CITY of NOVI CITY COUNCIL

Agenda Item 1
February 26, 2018

SUBJECT: Consideration for tentative approval of the request of Pulte Homes of Michigan, LLC, JSP17-62, for a Planned Suburban Low-Rise (PSLR) Overlay Development Agreement Application and Concept Plan for the Villas at Stonebrook development. The subject property is approximately 26 acres of land located on the east side of Wixom Road, north of Eleven Mile Road, in Section 17 (previously known as the Profile Steel property). The applicant is proposing 43 duplex units (86 homes total) in "age-targeted" ranch-style homes.

RULE HOMES
 WAXOM ROAD
 MULTI-FAMILY
 PSLR OVERLAY CONCEPT PLAN
 LAYOUT PLAN

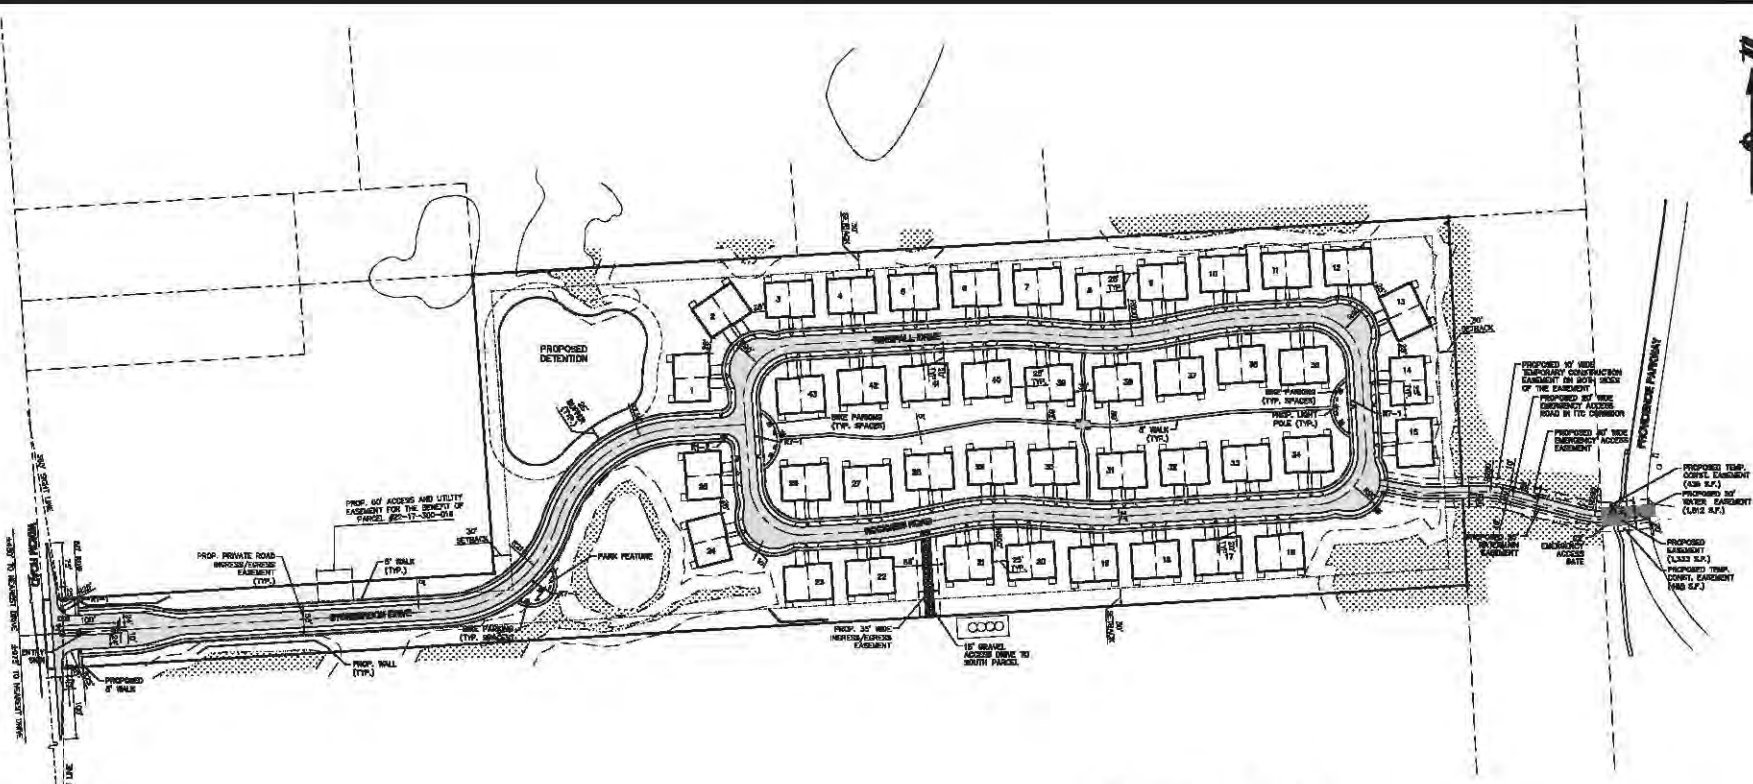
- a. The applicant should update the proposed boulevard cross-section detail on Sheet 13 to reflect the dimensions indicated on Sheet 05.
2. Although not warranted by the data presented in the TIA, the applicant has proposed both an entering and exiting right turn lane. Both lanes are designed in compliance with City standards.

Figure 1. City of Novi Regulated Wetland & Woodland GIS Coverage Map (approximate project boundary shown in red). Regulated Woodland areas are shown in green and regulated Wetland areas are shown in blue.

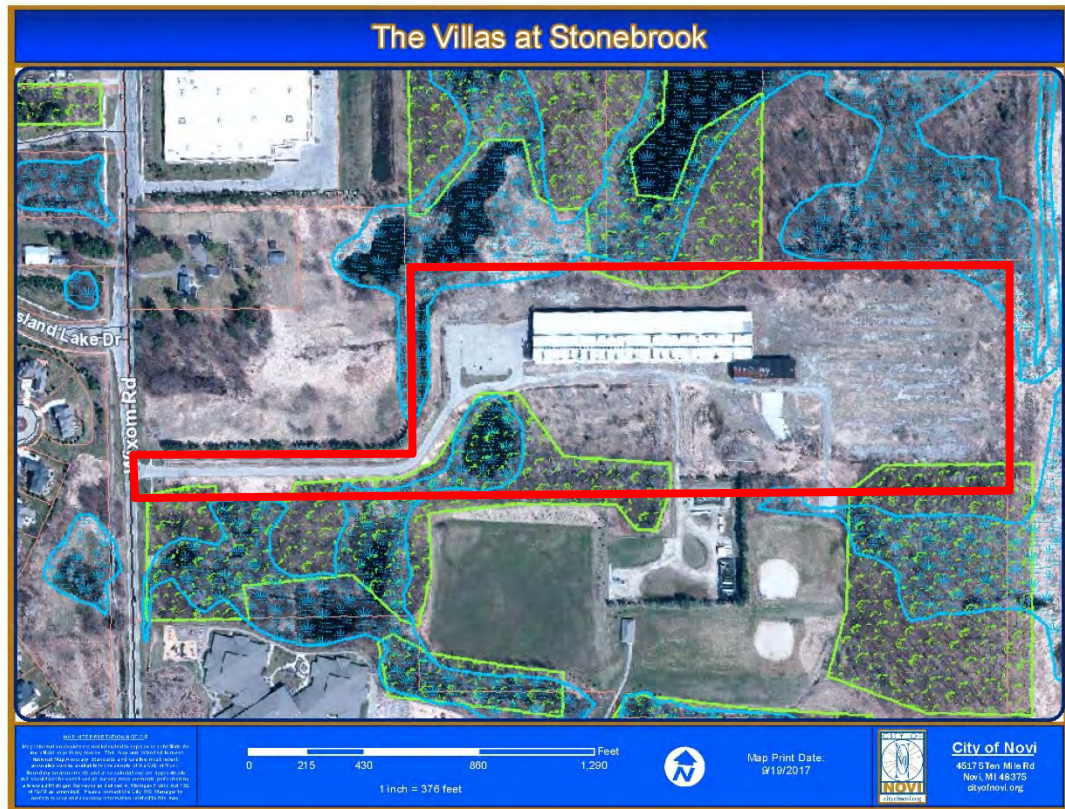
Based on our review of the Plan, Novi aerial photos, Novi GIS, and the City of Novi Official Wetlands and Woodlands Maps (see Figure 1); it appears as if this proposed project site contains both City-Regulated Wetlands and Regulated Woodlands. ECT continues to recommend that we conduct a wetland and

The Plan indicates numerous areas of existing wetlands on the site. In general, these wetland areas are located along the perimeter of the project site. Portions of these wetland areas appear to be included on the City of Novi Regulated Wetlands and Watercourse Map (see Figure 1, attached).

**BAYPORT
PRELIMINARY ELEVATIONS**

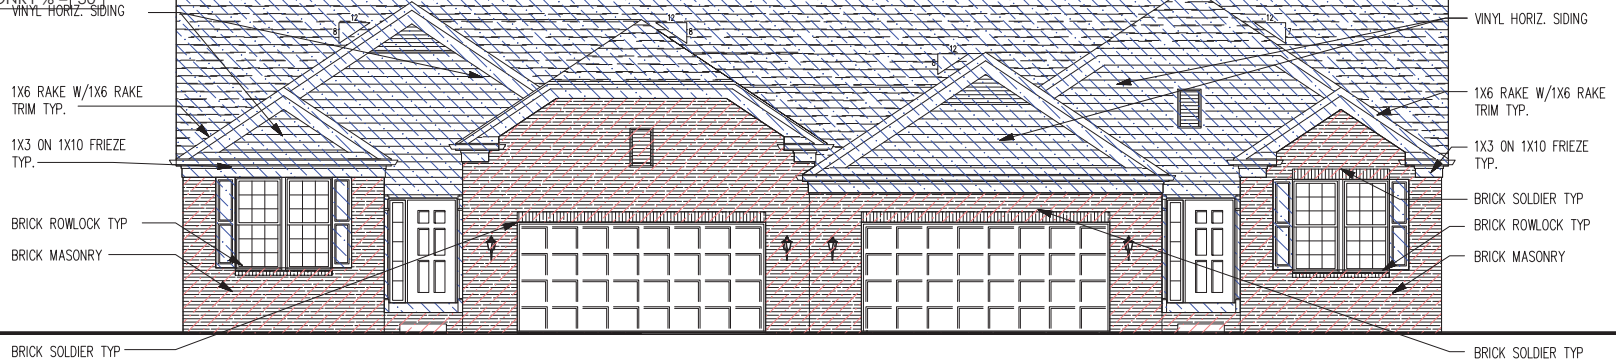
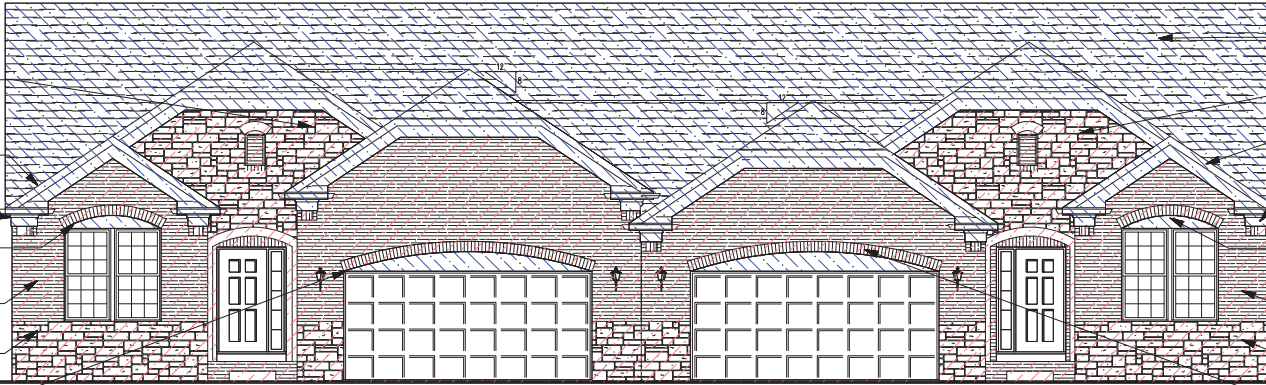
1. **Façade:** This deviation has been partially addressed after the Planning Commission meeting, with the applicant's stated intent to meet the minimum ordinance standards. The applicant has now submitted revised façade elevations drawings and calculations. The updated Façade review letter indicates that the drawings still do not meet the intent and provisions of the ordinance, but the applicant has subsequently agreed to replace the proposed vinyl siding with a compliant material, such as hardy board. The applicant has also agreed to provide brick on each elevation to meet the minimum façade ordinance requirements. The percentage of asphalt shingles exceeds the maximum allowed on the rear façade. The applicant will be asked to comply with the ordinance standards at the time of Preliminary Site Plan review, to meet the standards and design intent, with minor modifications being subject to the discretion of the City's Façade Consultant.

- f. The Site Plan shall meet the minimum required standards of the Façade Ordinance, with minor deviations to the percentage of asphalt shingles on the rear elevations to be approved by the City's Façade Consultant at the time of Site Plan Review.
